SAFETY RECALL

SC333

Date: 02/28/08 (Supersedes SC333 dated 12/19/07)

Subject: Incorrect Auxiliary Brake Light Switch — LEU Models

Figure 1 — Auxiliary Brake Light Switch Location

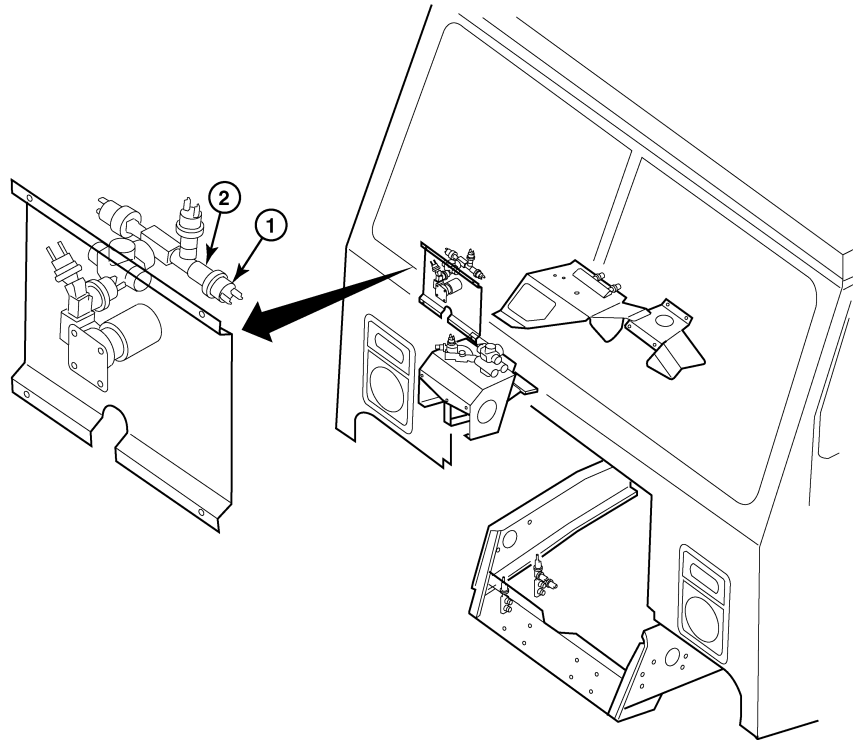
It has been determined that an incorrect switch may have been used in the auxiliary brake light circuit of certain LEU model chassis manufactured between October 9, 2006 and September 28, 2007. This switch, which illuminates the brake lights when the parking brakes are applied, should be a normally opened switch, whereas a normally closed switch was used on some vehicles. The incorrect switch will not allow cruise control to disengage when the service brakes are applied. Approximately 30 LEU model chassis are involved in this campaign. A list of affected vehicles has been sent to all applicable dealers.

The existing auxiliary brake light switch on all vehicles involved in this campaign must be inspected and replaced as required. The easiest method of determining if switch replacement is necessary is by noting the method of connection to the pressure switch manifold. If the switch is a push-to-connect type, it is incorrect and must be replaced with a threaded-type switch (part No. 1MR2472M). The existing push-to-connect fitting must also be replaced with a threaded fitting (part No. 63AX6). If the switch is a threaded-type, no further action is required. Before proceeding, verify Safety Recall eligibility by:

2. Access the auxiliary brake light switch. The switch is located inside the cab, on the right-hand side of the vehicle underneath the instrument panel (refer to the following illustration).

3. If the switch is a push-to-connect type, disconnect the harness connector from the switch, and then use the push-to-connect release tool (tool No. 9032-1800TRK) to depress the collet head on the fitting which releases the grip on the switch. The 9032-1800TRK tool is available through the MACK Parts System.

4. With the collet depressed, pull the switch from the fitting.
5. Remove the push-to-connect fitting from the pressure switch manifold.

6. Install a reducing fitting (part No. 63AX6) into the pressure switch manifold, and then install the replacement auxiliary brake light switch (part No. 1MR2472M) to the fitting.
